Pub. 72, Change #1 to December 1981 Edition

REVISIONS TO STANDARDS FOR ROADWAY CONSTRUCTION, RC-0-100 CHANGE #1 TO DECEMBER 1981 EDITION

Pub. 72 - 1981 Edition

STANDARDS FOR ROADWAY CONSTRUCTION RC 0-100

RC-57

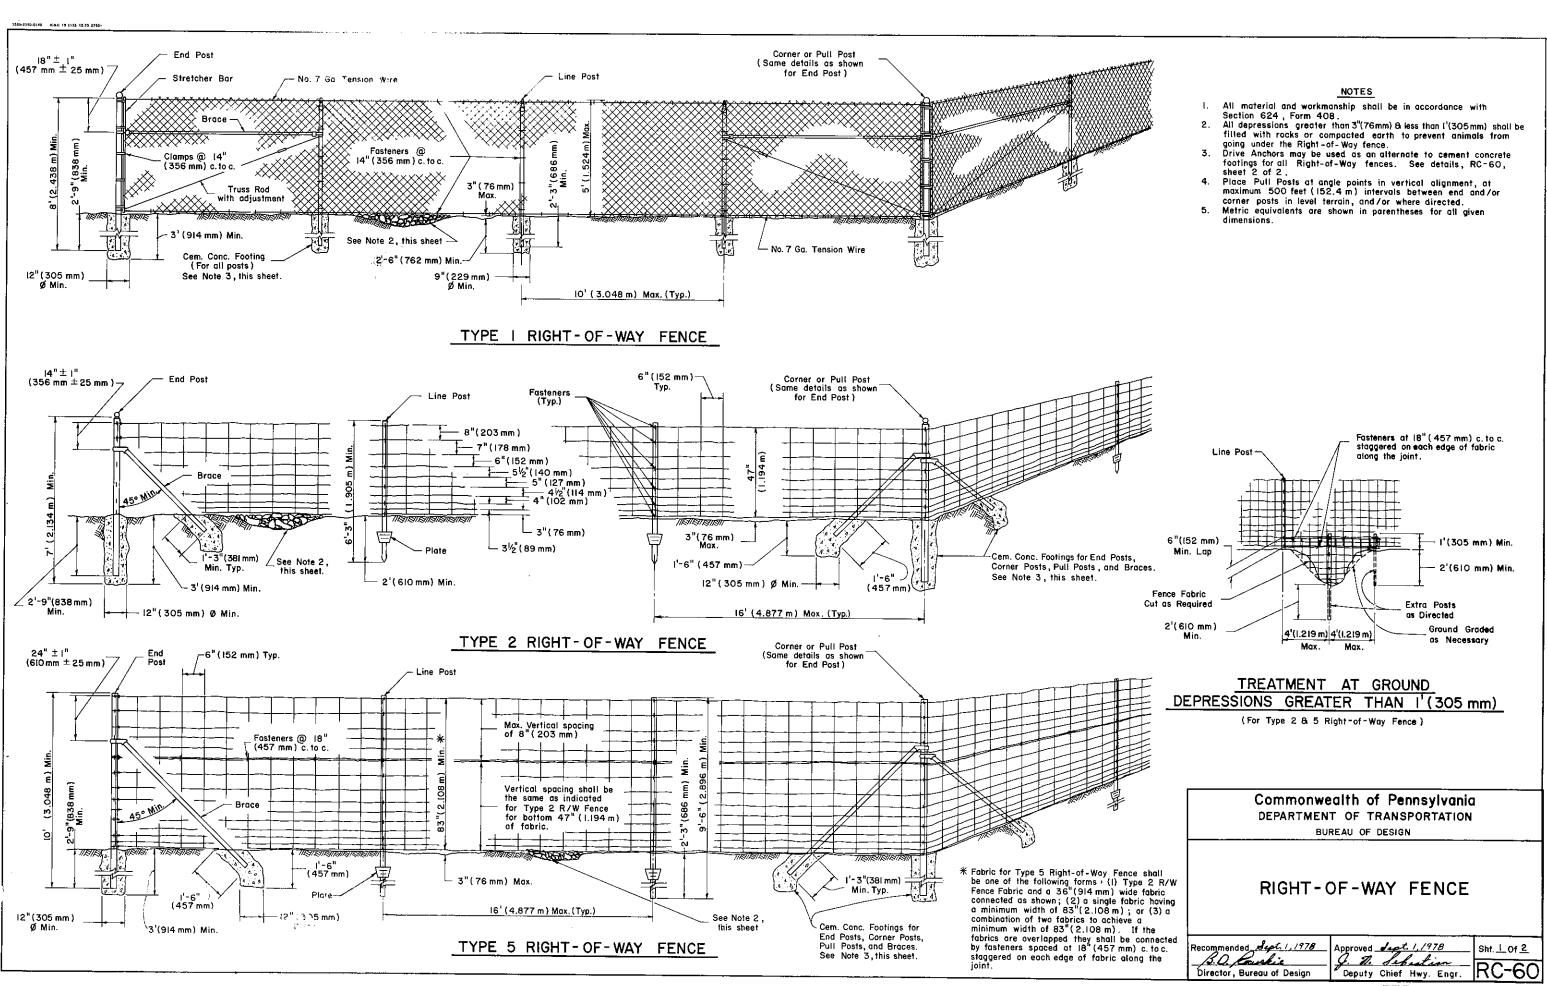
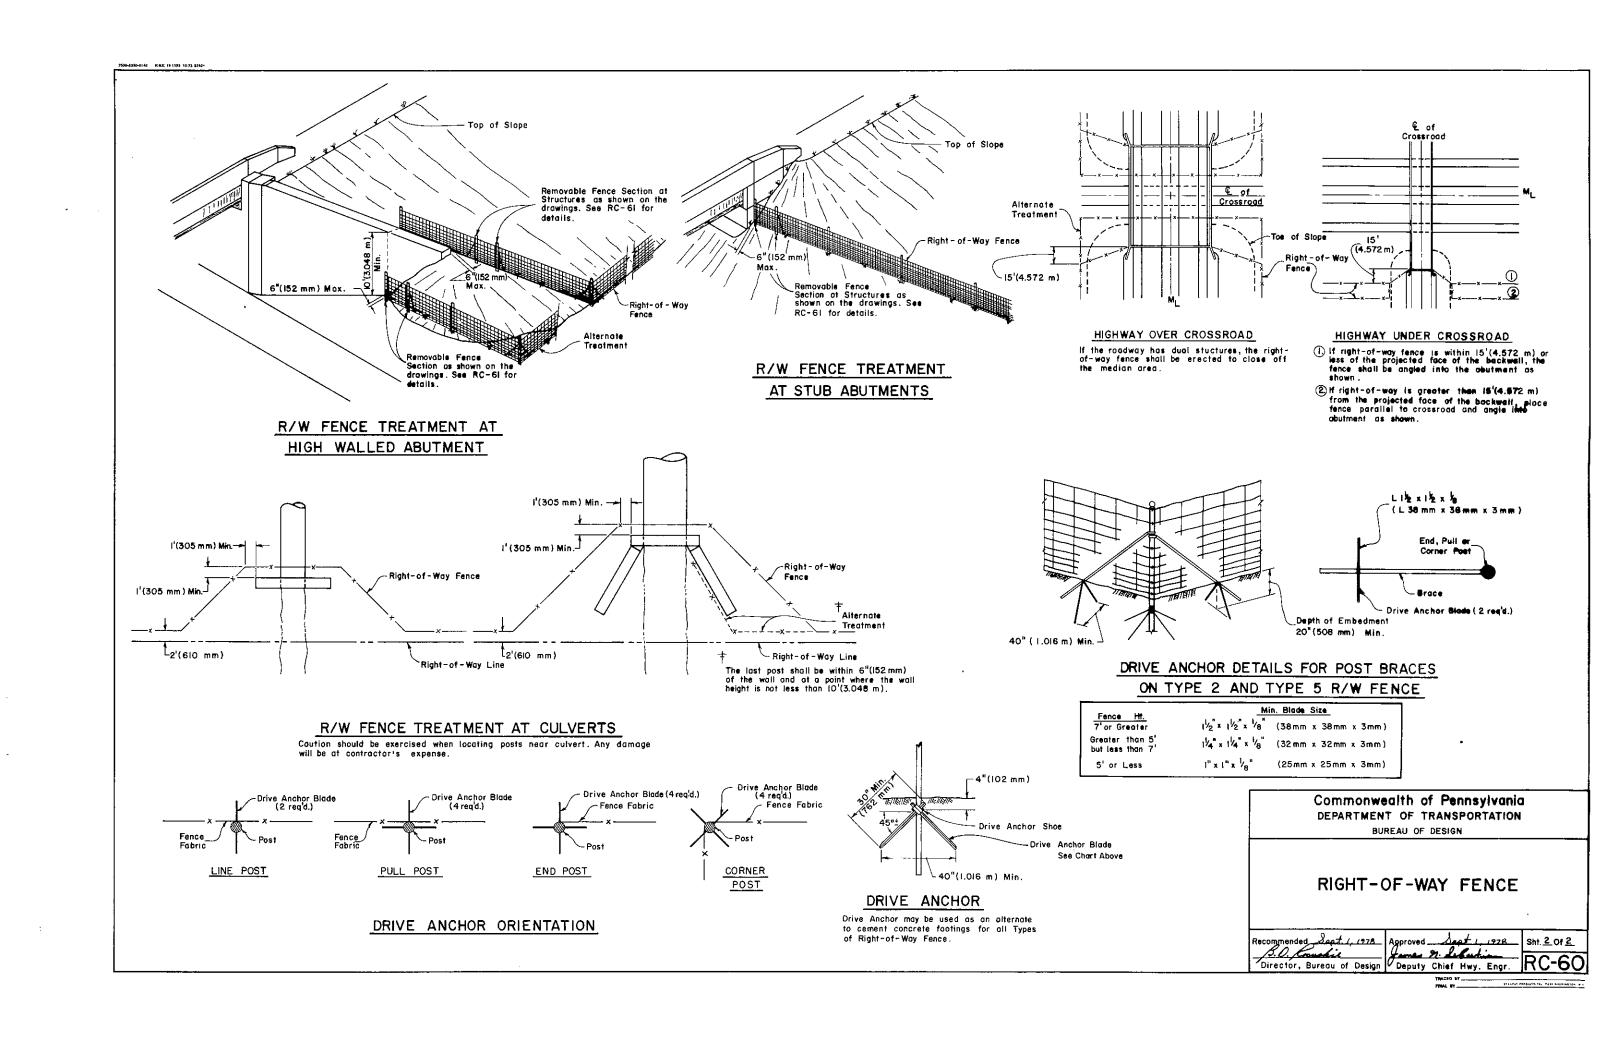
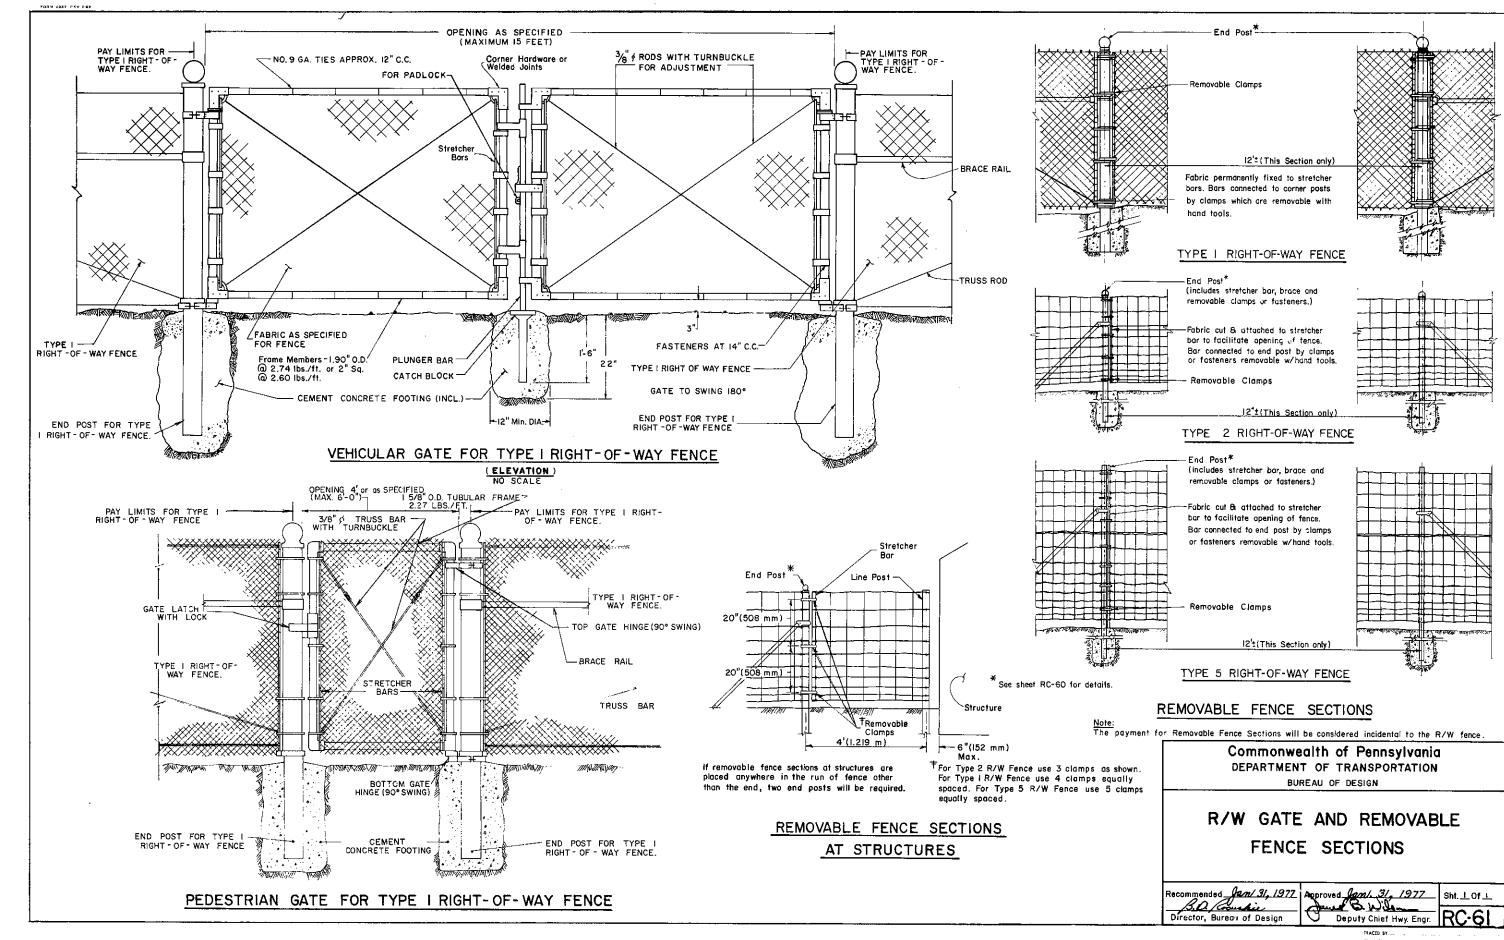
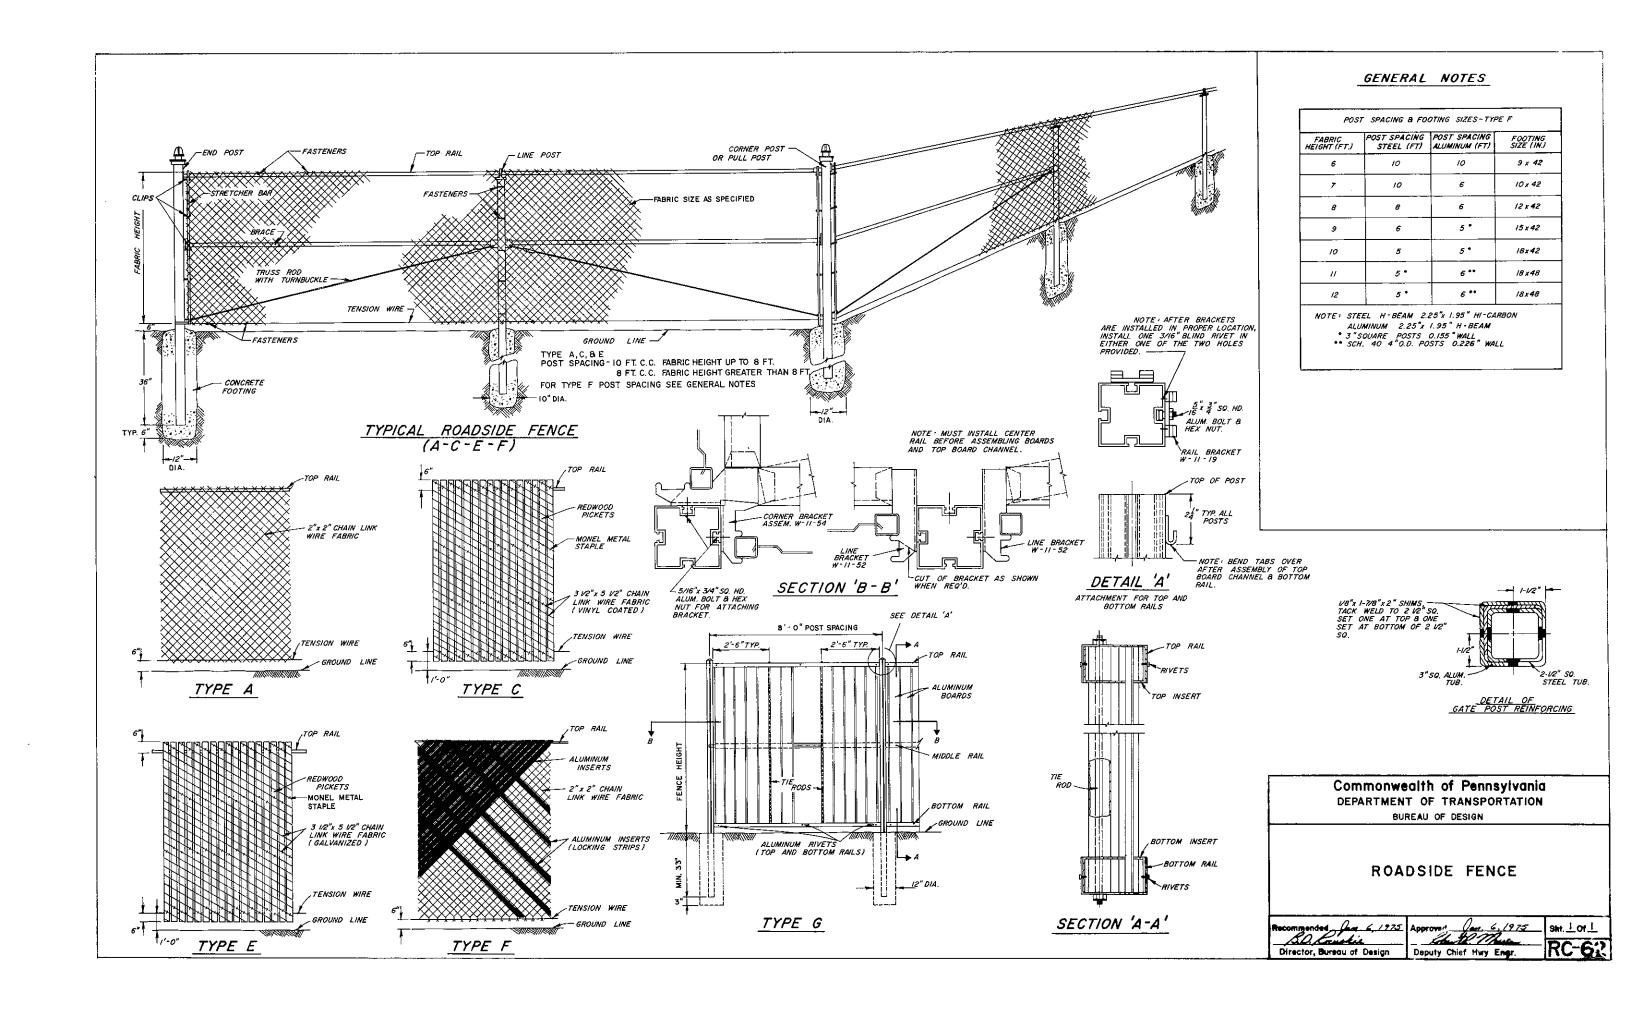
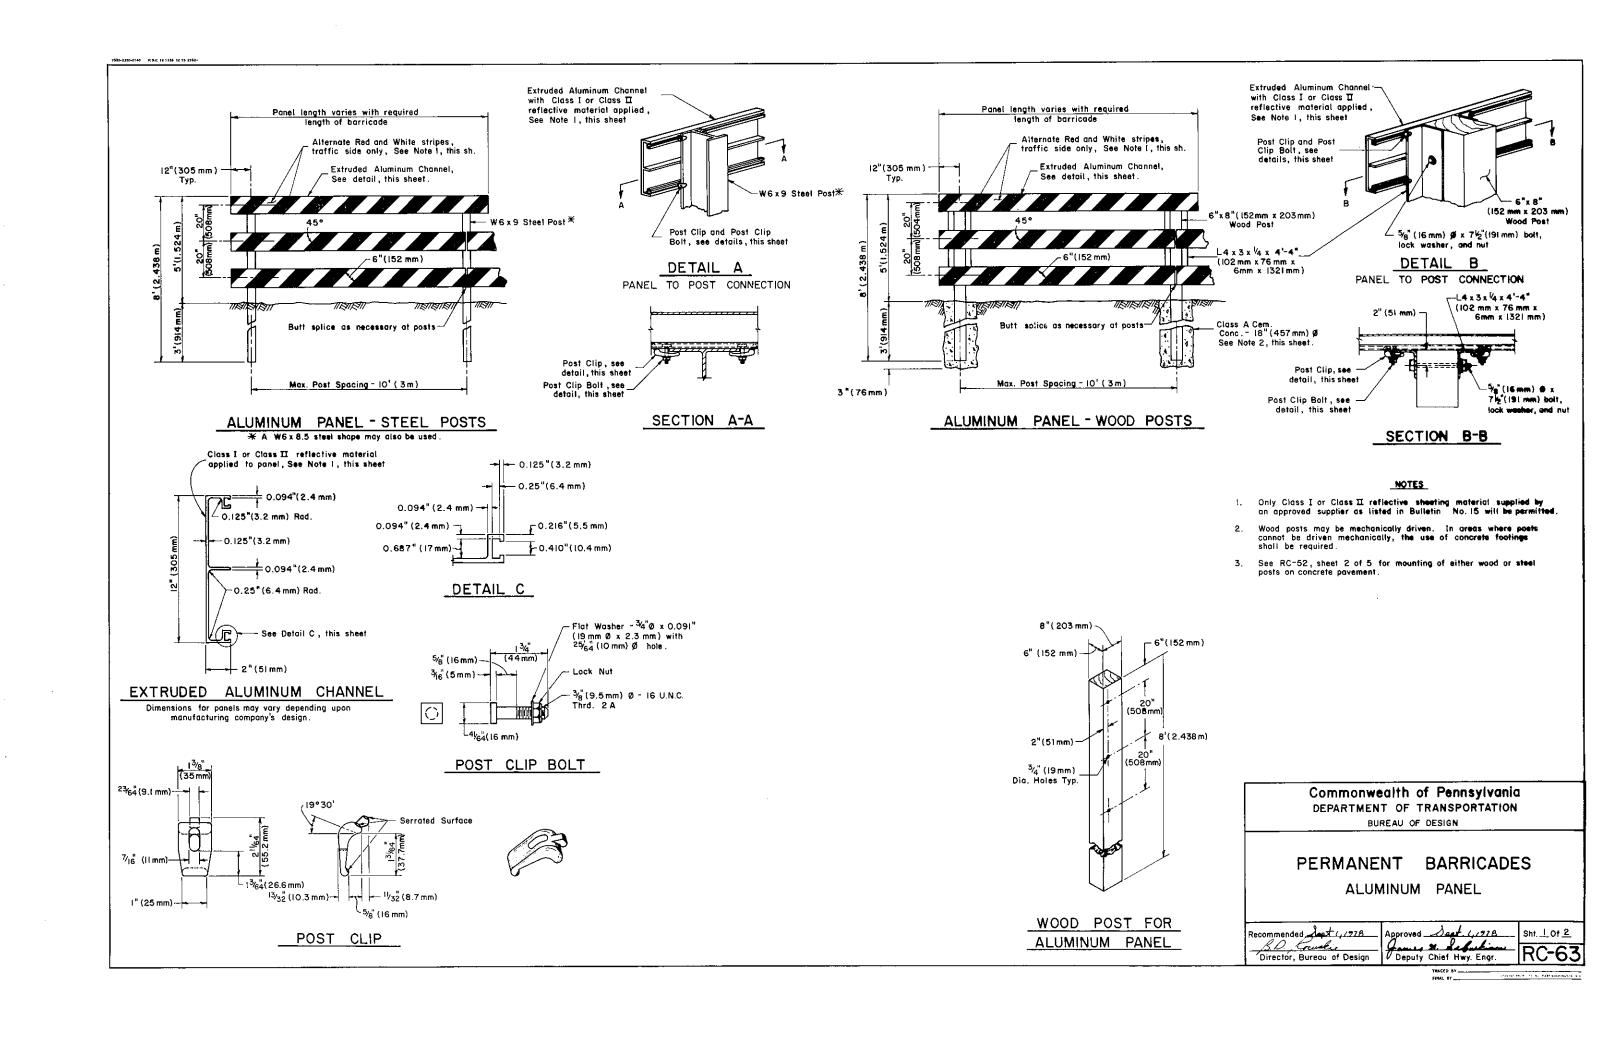
ommidd blockii i ion
RC-57	(1 of	5)	Redrawn. Permanent barrier details are provided; terminology was changed from "with" or "without joicontinuity" to cast-in-place, slip-form and precast construction; criteria added for use of delineation devices, a 20:1 sloped end transition and impact attenuators.
	(2 of	5)	Redrawn. Details are provided for slotted plate and tongue-and-groove barrier connection systems, for typical reinforcement and for ideal barrier orientation on superelevated sections.
	(3 of	5)	New sheet. Temporary barrier details are provided which include typical barrier connection systems, reinforcement and delineation requirements and placement of drainage slots.
	(4 of	5)	New sheet. Details are provided for typical end transition, reinforcement and minimum flare treatment. Criteria provided for use of impact attenuators.
	(5 of	5)	New sheet. Details are provided for typical barrier treatment at piers, transition details and inlet placement.
